II. Markup of Proposed Change

FIGURE 2.1-1

REACTOR CORE SAFETY LIMIT - FOUR LOOPS IN OPERATION

IV. Safety Evaluation of License Amendment Request 93-03 Proposed Change

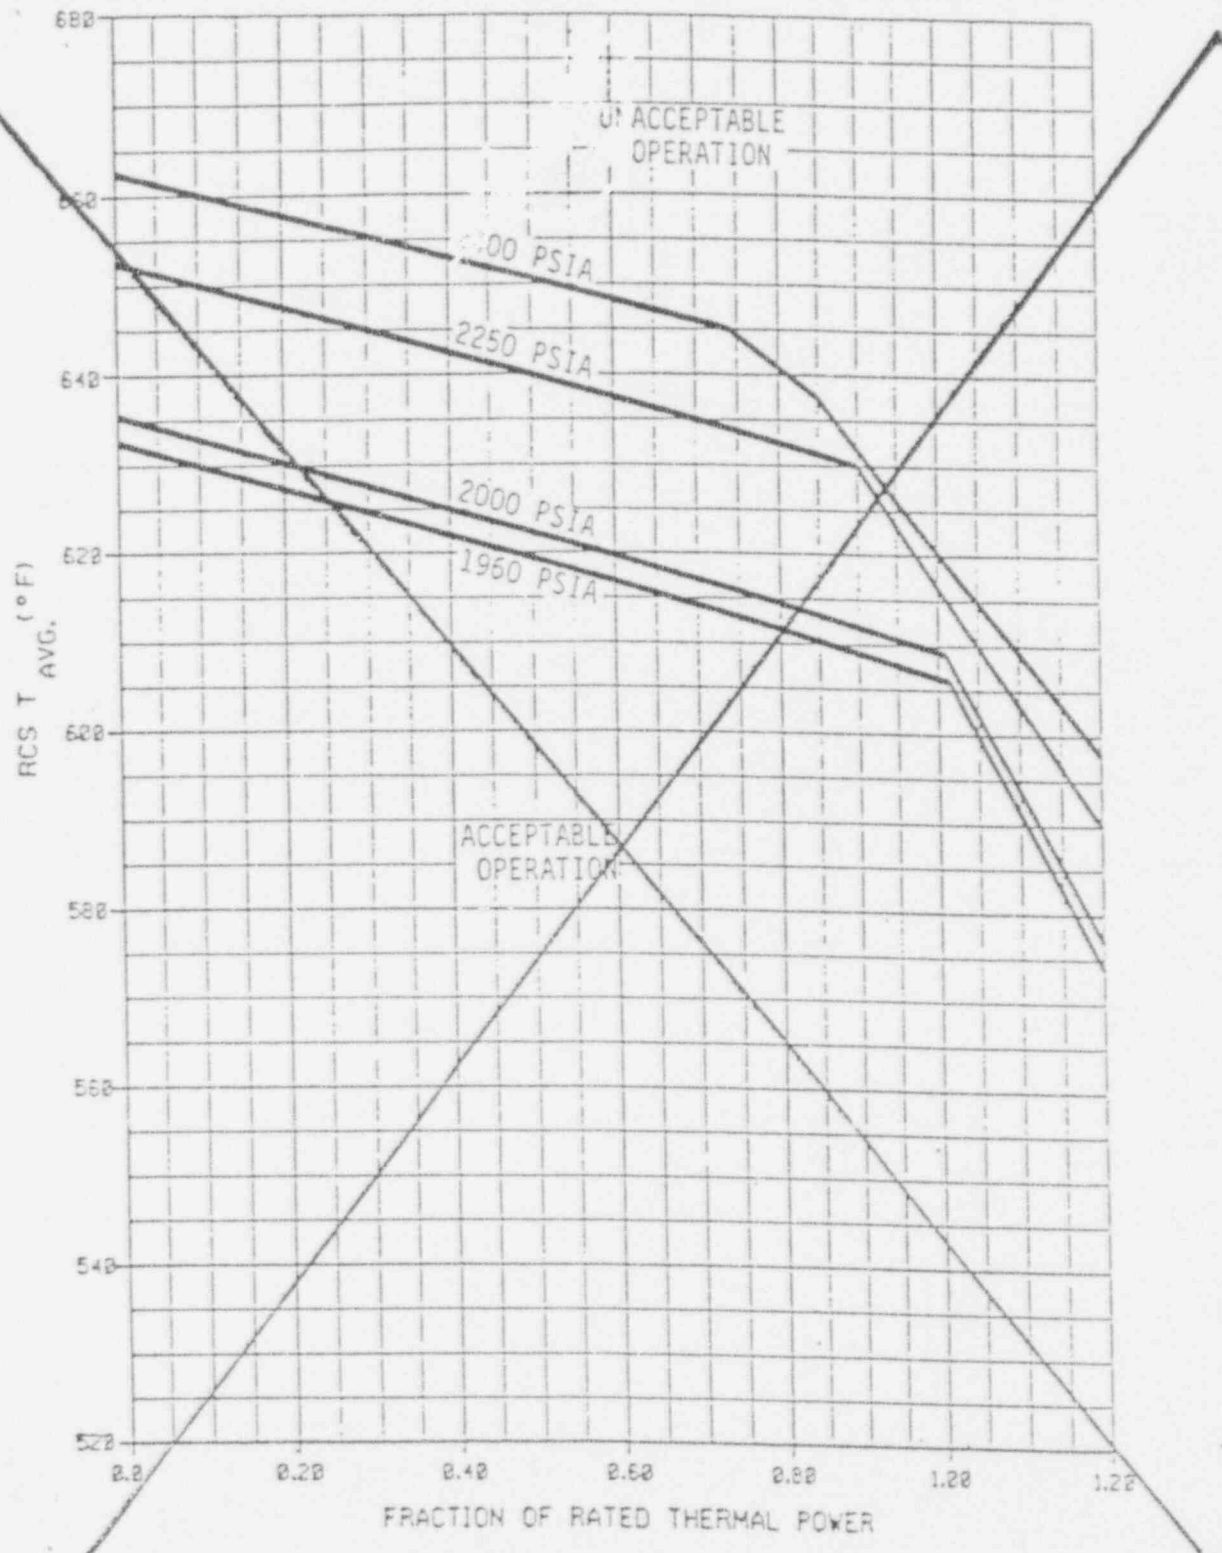
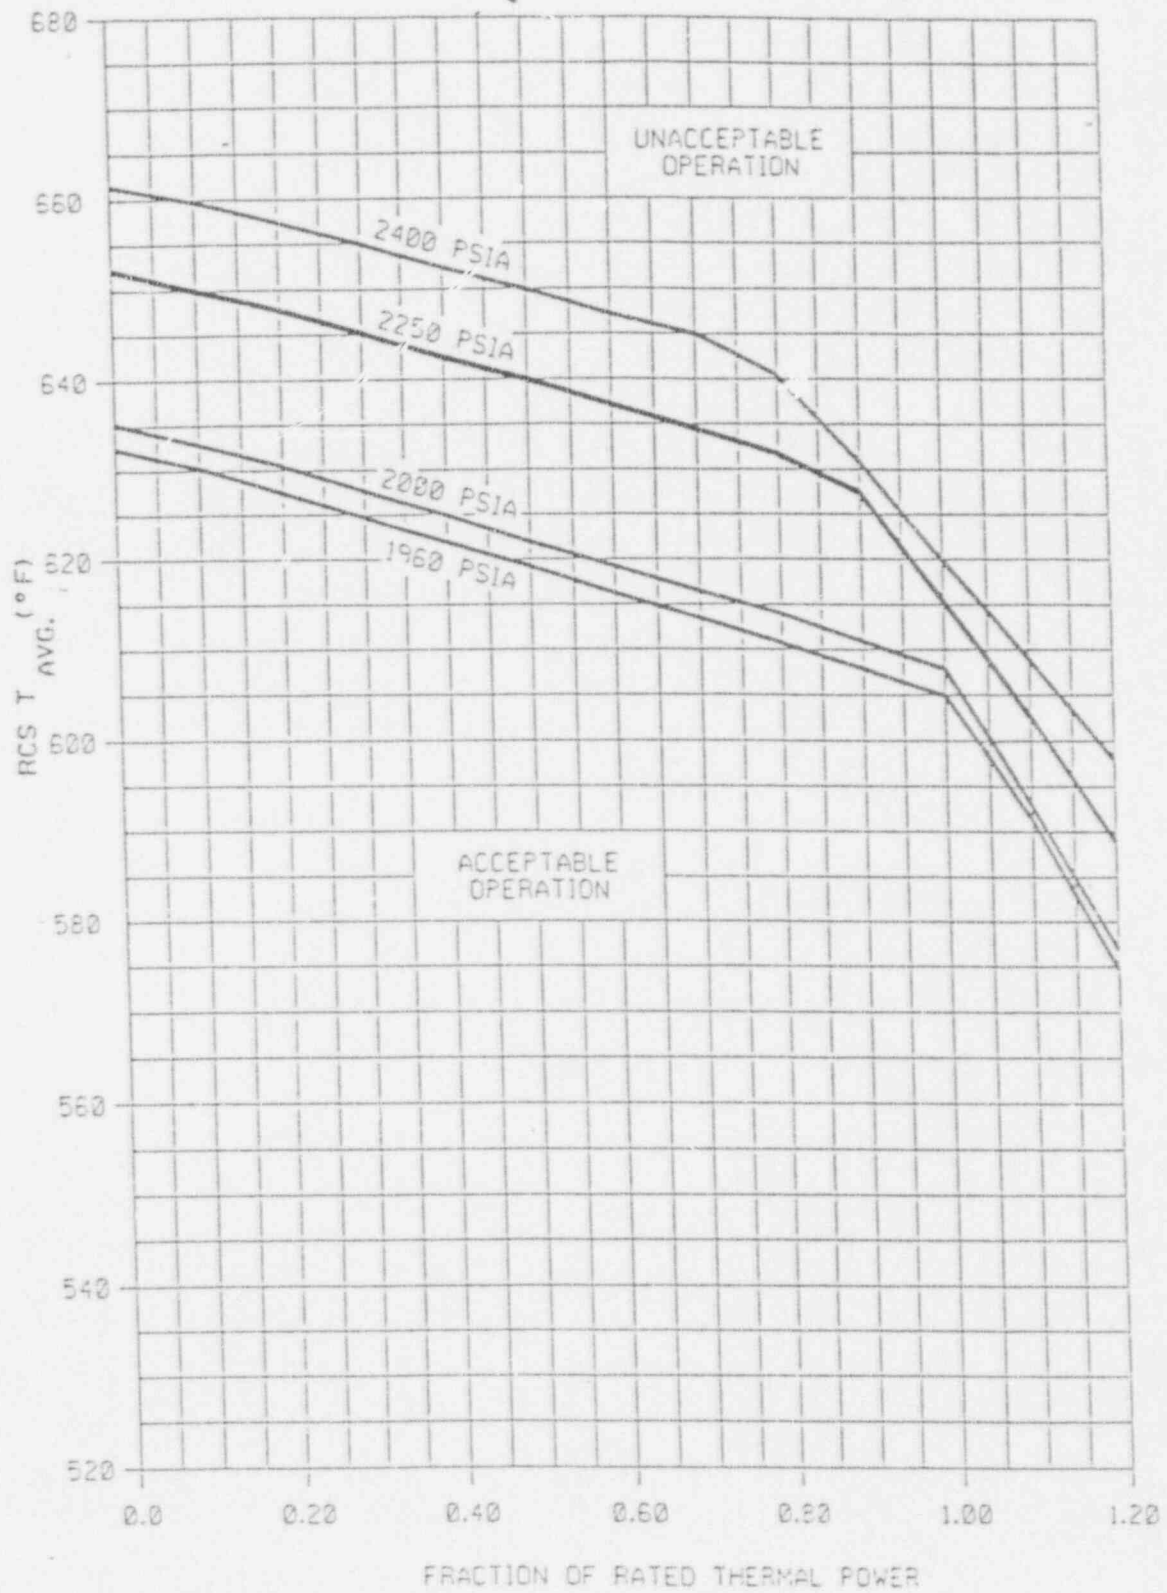
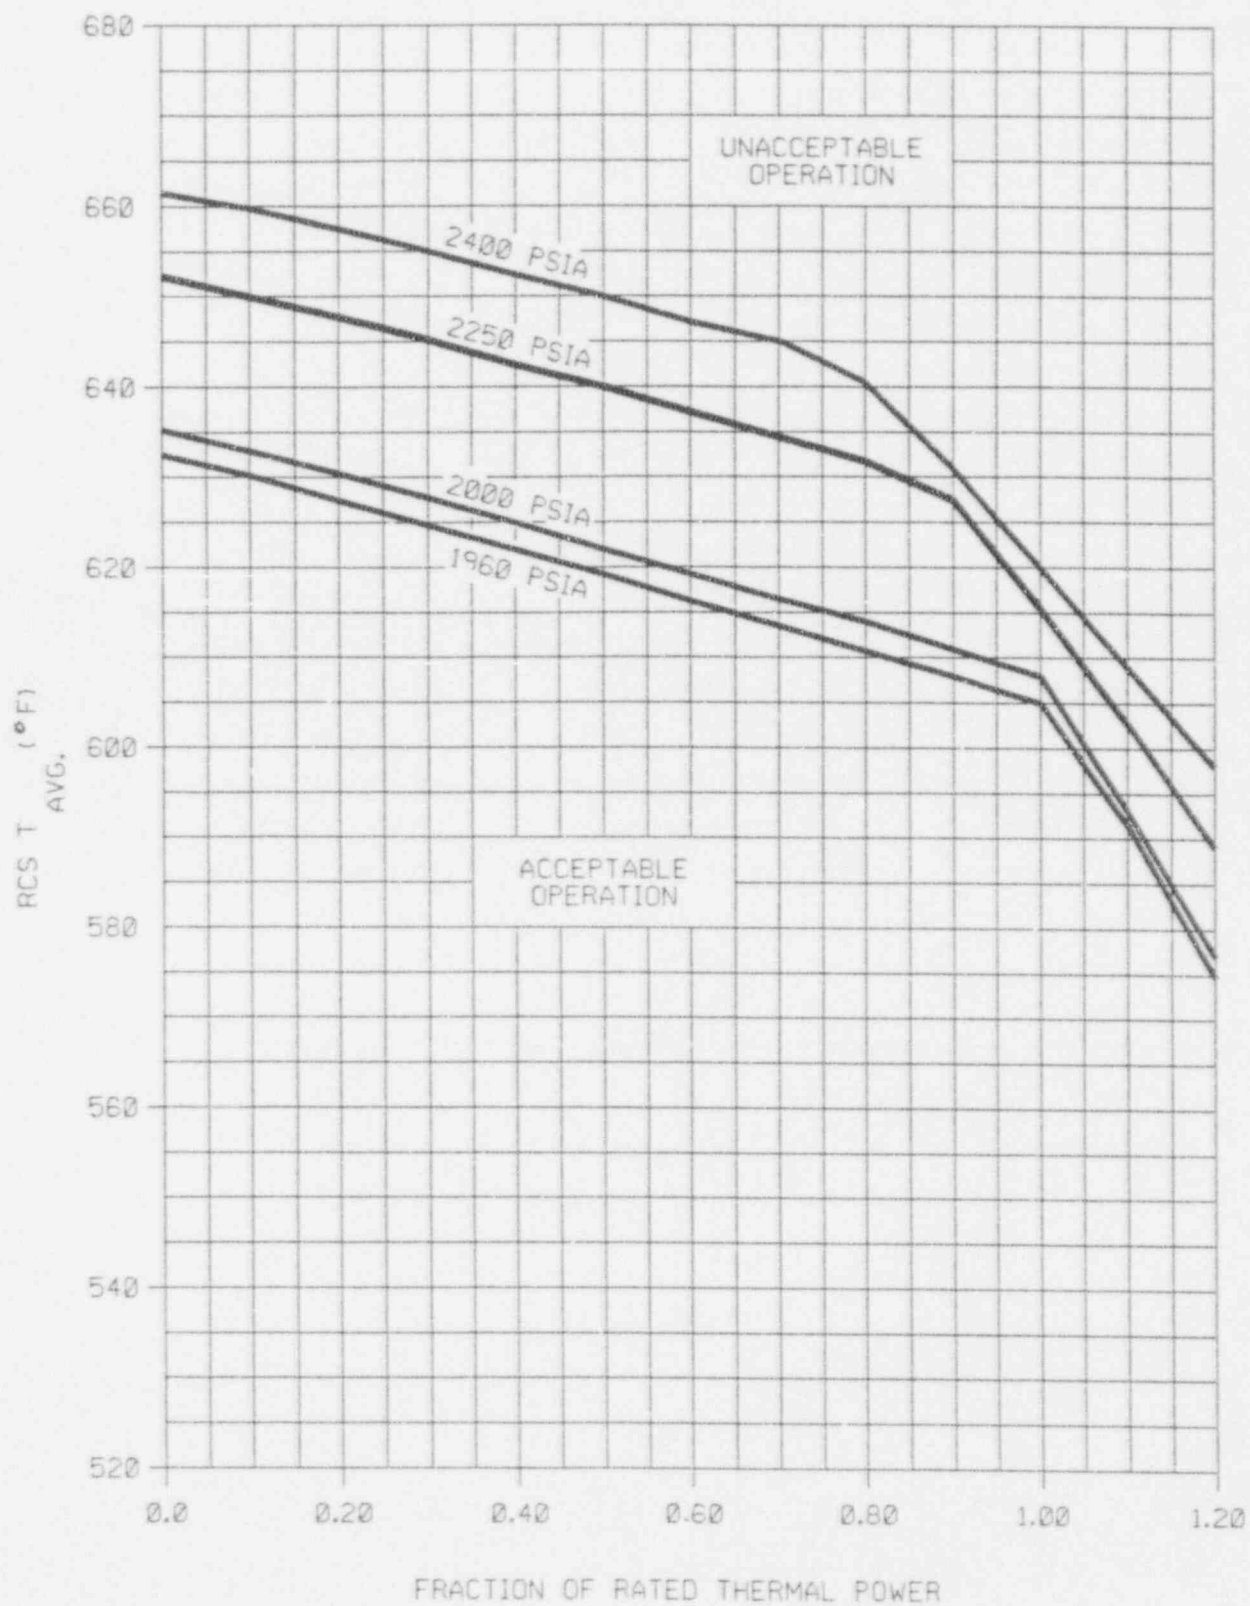
Seabrook Station Licensee Event Report (LER) 92-02-01 reported that the curves of Technical Specification Figure 2.1-1, Reactor Core Safety Limit - Four Loops in Operation, were non-conservative. The non-conservative curves were identified as a result of a North Atlantic review of the Technical Specification values provided to North Atlantic by Westinghouse. It was determined, through a comparison of Westinghouse design documents to the actual curves in Figure 2.1-1, that the curves in the region of 80% to 110% of rated thermal power (RTP) do not accurately represent the loci of points upon which the curves are based. For example, the 1960 psia curve at 100% of RTP should provide a value of 605.0°F, while the actual curve in Figure 2.1-1 is closer to 606.5°F. There are other points in this region that can be determined to be non-conservative when compared to the loci of points.

The curves of Figure 2.1-1 show the loci of points of Rated Thermal Power (RTP), Reactor Coolant System (RCS) pressure and average RCS temperature (Tavg) for which the minimum Departure from Nucleate Boiling Ratio (DNBR) is no less than 1.30, or the average enthalpy at the reactor vessel exit is equal to the enthalpy of saturated liquid. The safety limit ensures that the integrity of the fuel is not challenged.

This condition was reported to the NRC in Licensee Event Report 92-02-01. One of the corrective actions specified in LER 92-02-01 was to revise Technical Specification Figure 2.1-1 to include curves which accurately reflect the loci of points upon which they are based. This submittal addresses that corrective action.

The revision to the curves to accurately reflect the loci of points upon which the curves are based will ensure that if the Reactor Protection System trip functions, as discussed above, are exceeded the evaluations made to verify if a safety limit has been exceeded will be accurate. A review of the Seabrook Station Technical Specifications Bases and Updated Final Safety Analysis Report Sections 4 and 15 verifies that the proposed change does not alter the design, function or operation of the plant. This proposed change does not affect any existing accident analyses, and it does not introduce the possibility of any accidents or malfunctions not already analyzed. Since the proposed change is providing the more conservative values for Figure 2.1-1 to reflect the design basis it does not reduce the margin of safety as defined in the bases of the Technical Specifications and preserves the margin originally established. The revision to the curves will not affect any methods of operating. This revision ensures that the design basis and the safety limits are accurately and appropriately reflected in the Technical Specifications and will ensure

The correction of the curves in Figure 2.1-1 does not decrease the margin of safety as described in the Bases of the Technical Specifications, but rather ensures that the margin of safety as presented in the Bases and established by the design basis is maintained.
